COUNTERMEASURE SET UPGRADE

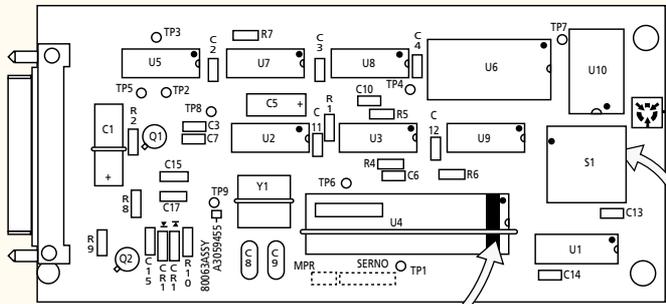
To determine if your countermeasure set needs an upgrade, check the A9 card for a red strip on the U4 chip and a red dot on the S1 thumb wheel switch.

If EPROM chip (U4) has a red strip marked, width-wise across the top back portion...

...and thumb wheel switch (S1) has a red dot on its side, then no upgrade is required

IF U4 IS MISSING A WIDTH-WISE RED STRIP OR S1 IS MISSING A RED DOT ON THE SIDE, CONTACT CECOM'S CLIFF VERMONT AT DSN 992-2472, (732) 532-2472 OR E-MAIL cliff.vermont@mail1.monmouth.army.mil FOR UPGRADE DETAILS.
